# UNITED STATES PATENT AND TRADEMARK OFFICE

**Office Action Summary**

10/807,380

MATSUI, TSUTOMU

**Fig. 2*****Claim Rejections - 35 USC § 103***

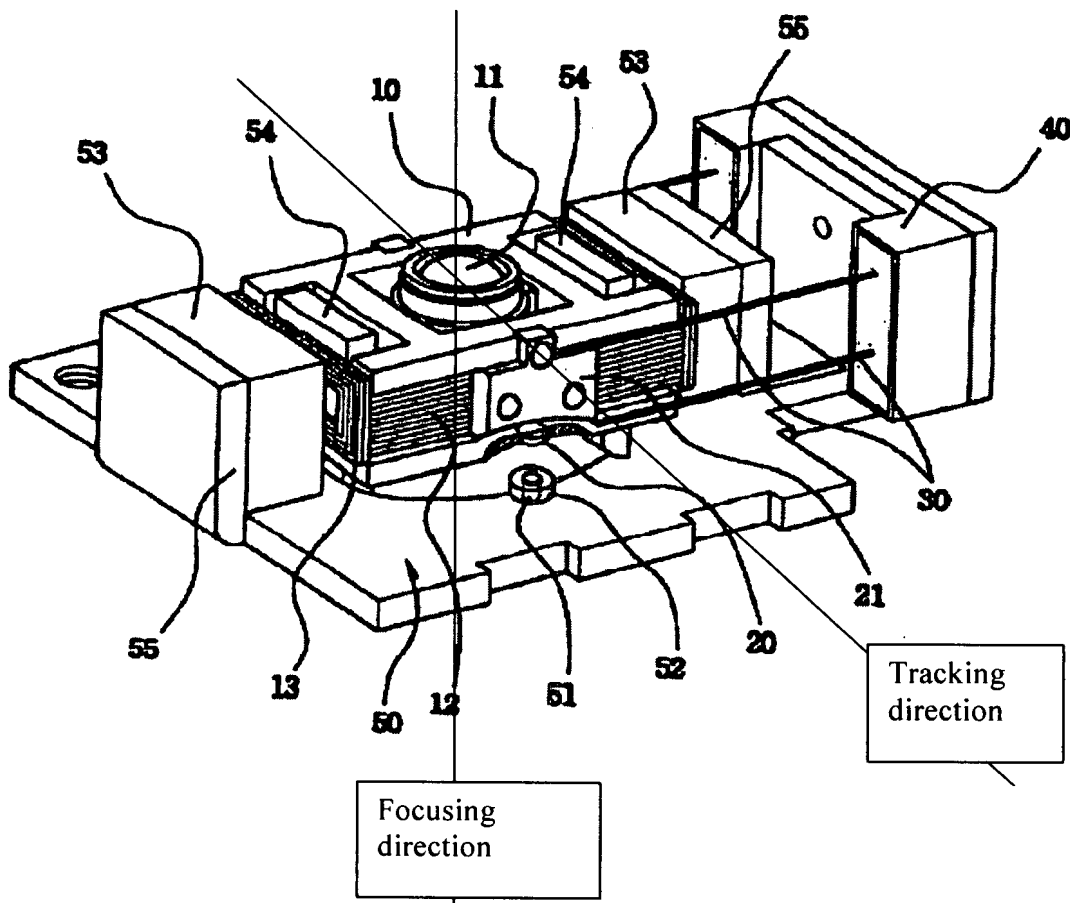
See the rejection applied thereto in the last Office action dated 04/30/07, and further see Fig. 2 that shows the focusing coil (12) is wound around the lens holder (10) in plane perpendicular to the focusing direction, and see Fig. 2 that also a pair of fixed magnets (53) arranged in a direction perpendicular to the focusing and tracking directions. It is noted that no directions are labeled in Fig. 2, but one of ordinary skill in the art would immediately recognize that the focusing direction is a vertical direction relative to a recording surface of the disc and the tracking direction is a radial direction relative to the disc as described in Fig. 2 below. It is also noted that the tracking direction of the actuator must be in a direction as described in the Fig. 2 below due to the structure arrangement of the magnets 53, tracking coils 13 and suspension wires 30.

5. In response to Applicant's arguments filed 7/30/07, Applicant should note that based on the arrangement of the magnets 53, tracking coils 13 and suspension wires 30 of the actuator shown in Fig. 2 of Jeong, it is technically impossible for the actuator to be moved in a direction along the magnets 53 as the tracking direction as described by Applicant in attached Fig. 2 due to the magnet flux from the magnets 53 supplied to the tracking coils 13 and the movement of the suspension wire 30. Jeong, according to column 5, lines 63-67, stated that the focusing and tracking operations of the actuator shown in Fig. 2 remain the same as those conventional optical pick-up actuator used in general CD player, and examiner believes that there is no such conventional optical pick-up actuator having the same structure arrangement as shown in Fig. 2 of Jeong capable of moving in the direction along the magnets 53 as the tracking direction as described by Applicant in attached Fig. 2. Accordingly, Jeong, according to Figs. 1-7, as applied to reject claims 1-4, and in combination with Suzuki as applied to reject claims 5 and 6, do show all the features of the instant claimed invention.
